STAFF RECOMMENDATION
2020 10th Avenue South
February 20, 2019

Application: Demolition-Partial; New Construction—Addition;
District: Waverly-Belmont Neighborhood Conservation Zoning Overlay
Council District: 17
Map and Parcel Number: 10509041200
Applicant: Tarl LaRocco
Project Lead: Melissa Baldock, melissa.baldock@nashville.gov

Description of Project: Application is for a two-story addition behind the historic one-story house. The project involves enclosing a side porch and altering window openings. **Recommendation Summary:** Staff recommends approval of the window opening alterations and the demolition of the rear addition, detached garage, and detached carport, finding that their demolition meets the guidelines' Section V.B.II. for appropriate demolition. Staff recommends disapproval of the partial demolition of the front door frame and other detailing on the historic house, finding that it does not meet Section V.B.II. for appropriate demolition but rather meets Section V.B.I. for inappropriate demolition. Staff also recommends disapproval of the addition, finding that its height, scale, design, removability, and roof form do not meet Sections III. and IV. of the design guide

Figures 8 & 9 show the proposed window alterations to the side of the historic house. Staff finds these alterations to be appropriate.

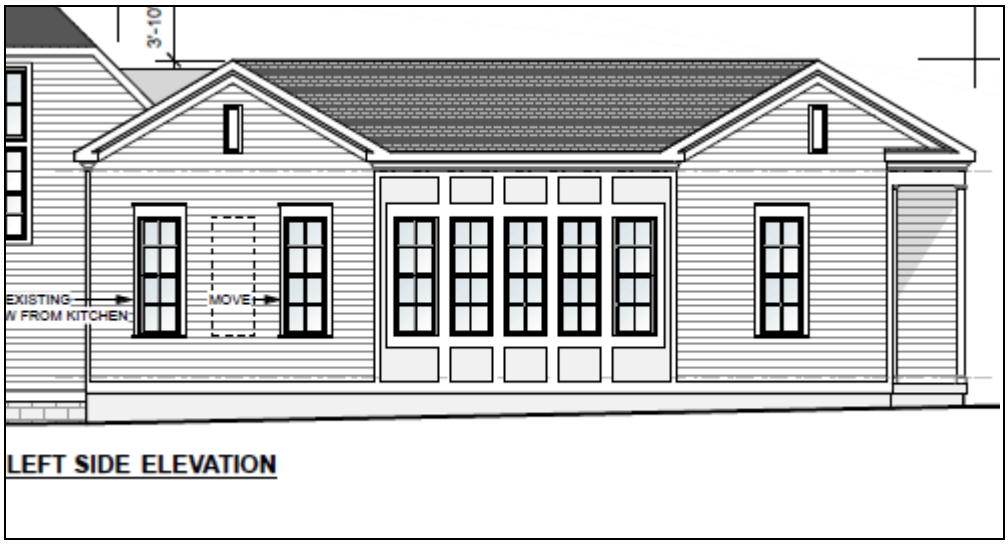
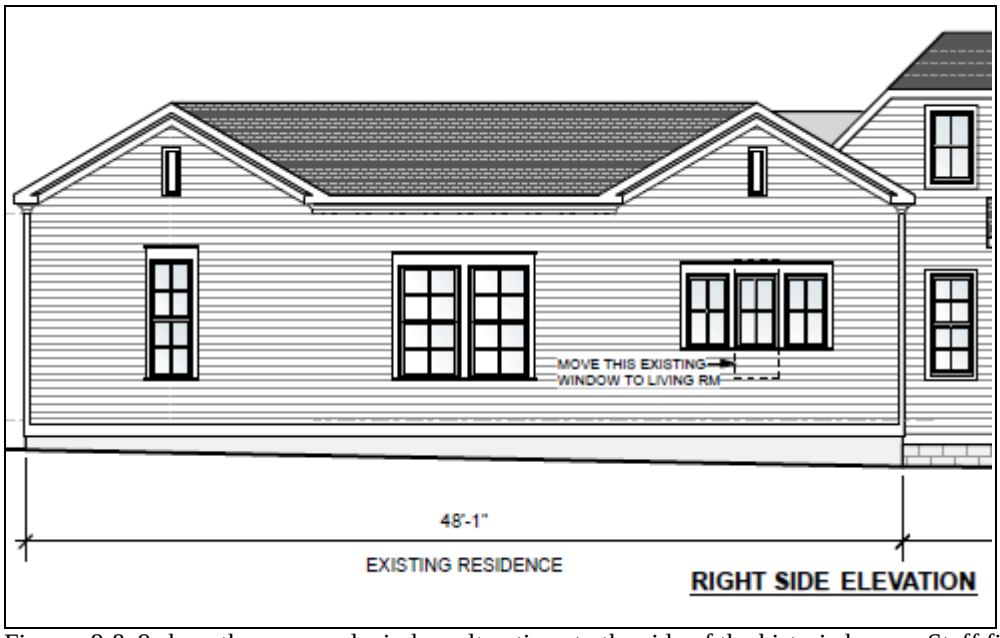
The applicant is proposing to alter window and door openings on the right and left facades towards the back. Alteration to window openings on the historic house is considered to be partial demolition. On the left elevation, the applicant is intending to move the existing window opening slightly to the right and to move the existing window opening from the back of the right elevation to this façade (Figure 8). The window opening on the right will be replaced with three shorter window openings (Figure 9). Because these window alterations are happening towards the back of the historic house and because the applicant intends to use the same casings and windows, staff finds these alterations to be appropriate.

Figure 10. Staff finds that the removal of the appendage at the rear of the house to be appropriate.

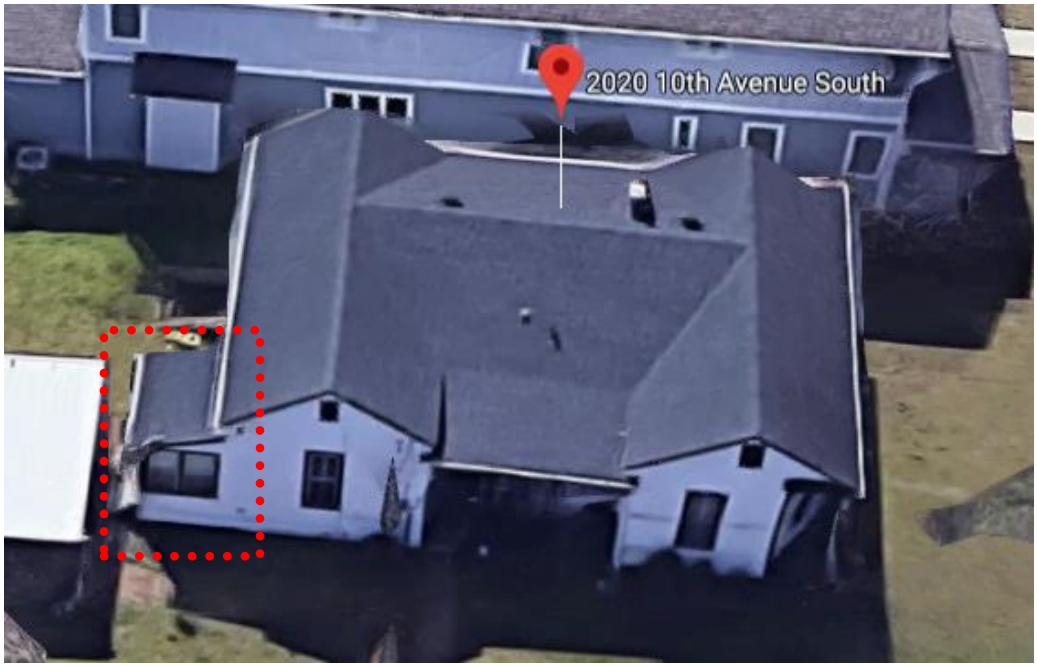
The applicant is proposing further to remove a small, rear porch portion of the house (Figure 10). The rear porch of the house is not seen in any of the older maps for the house and was therefore likely constructed after 1957. The structure has a separate roof form from the rest of the house, and staff finds that its date of construction, location at the rear of the house, and roof form do not contribute to the historic character of the house. Finally, the applicant is proposing to remove a detached rear carport and a detached garage (Figure 11). Neither structure appears on the 1957 Sanborn map, and neither contributes to the historic character of the house, the site, or the overall neighborhood. Staff therefore finds demolition of the rear porch, garage, and carport to be appropriate.

Figures 13 & 14. The floor plan and elevation showing the area of the enclosed porch.

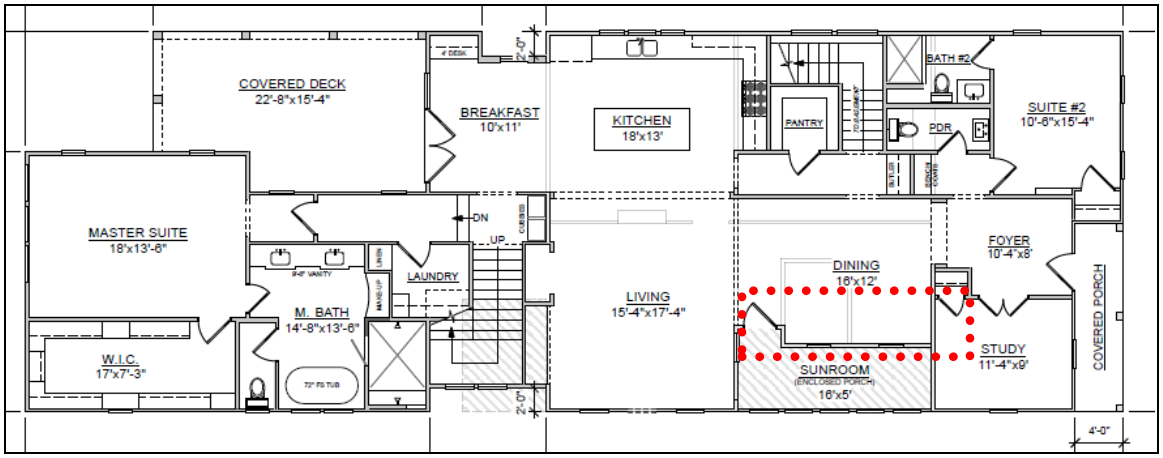
Design: Staff finds that the addition's height, scale, and taller roof form contrast greatly with the historic house at 2020 10th Avenue South. In addition, staff finds that the design of the proposed enclosure of the side porch is not appropriate (Figures 12, 13, and 14). Although the plans show that the exterior wall will remain, staff finds that the design of the enclosure lacks the transparency and openness required to indicate that this was once an open porch. The Sanborn maps from 1908, 1914, and 1957 all show that this area was always a side porch (Figures 15, 16, and 17). Staff finds the side porch configuration is a significant part of this historic house's form and should be preserved. Staff therefore recommends that the side porch element be designed to be more open in nature so – for instance all glass or screened – so that the exterior wall can still be read through the enclosed porch. The addition of posts to the enclosure would further help to make the element read more as an enclosed porch rather than a new wall.

SITE PLAN

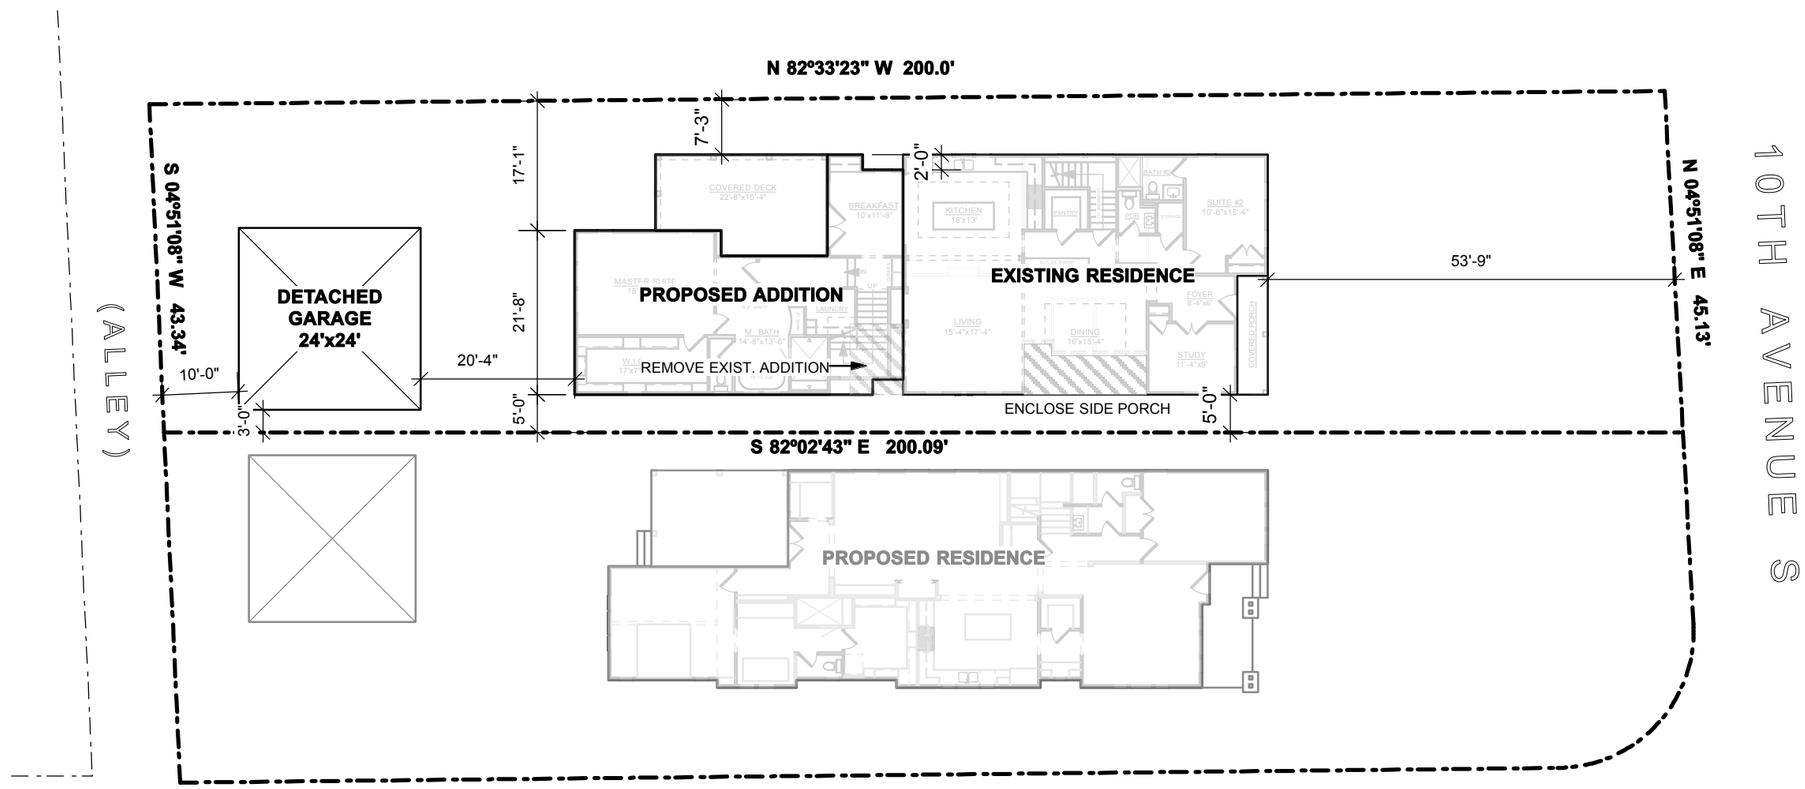
Setback & Rhythm of Spacing: The site plan shows that the addition meets all base zoning setbacks. It shows that the addition will be five feet (5') from the left side property line and seven feet, three inches (7'3") from the right side property line. It will be over fifty feet (50') from the rear property line. Staff notes, however, that the first floor plan shows different setbacks. It shows the addition as being four foot, six inches (4'6") from the left side property line and seven feet, seven inches (7'7") from the right side property line. Since the official survey for the lot shows the existing house as being five feet (5') from the side property line and both plans show the addition as lining up with the historic house, staff assumes that the site plan is correct and the first floor plan is erroneous. Although staff finds that the proposed setbacks as shown on the site plan are appropriate and meet Sections III.C. and IV. of the design guidelines, staff recommends that all future drawings show the accurate setbacks.

ELEVATIONS

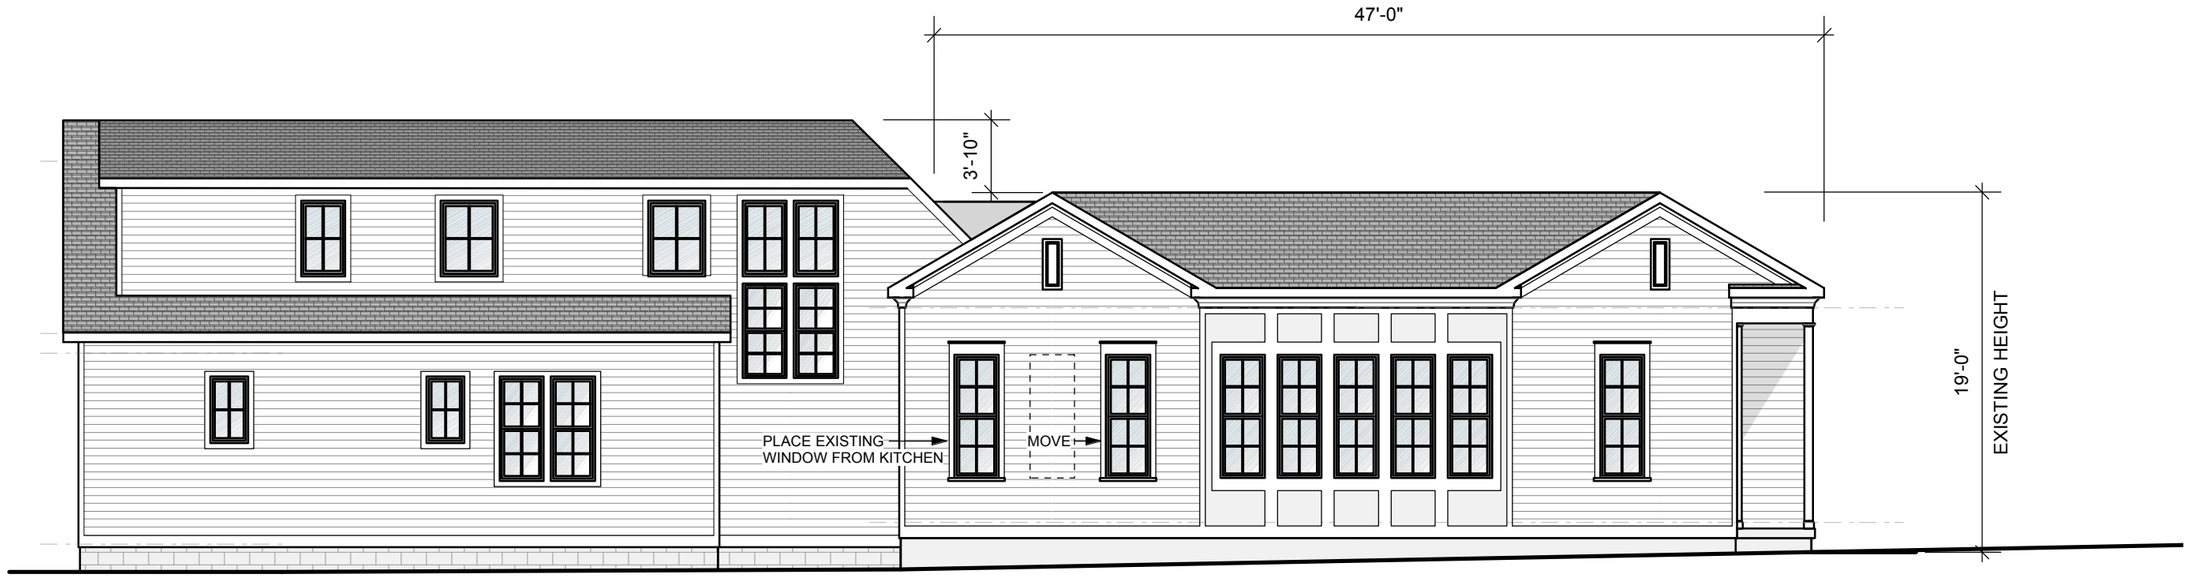
<u>Height & Scale</u>: The applicant is proposing a two-story addition to this one story house. The addition is proposed to be three feet, ten inches (3'10") taller than the historic house. Where the addition ties into the rear of the historic house, its eave is six feet (6') taller than the eave of the historic house and about nine inches (9") taller than the historic house's ridge height. The design guidelines state, "*when a taller addition is the only option, additions to single story structures may rise as high as 4' above ridge of the*

existing building." In this case, staff does not see a taller addition as the "only option" for adding onto this house. There are no site constraints or easements to prevent the applicant from adding onto the rear with an addition that is no taller than the historic house. Even though the taller portion of the addition is inset two feet (2'), staff finds a two-story or even a one-and-a-half story addition to be inappropriate to this true one-story house.

Roof form: The proposed addition has pyramidal roof form that is not appropriate for this historic house. The taller eave heights on the side facades and the large amount of roof visible above the front façade are not appropriate for this one-story historic house. Staff finds that the addition's roof form contrasts greatly with the roof form of the
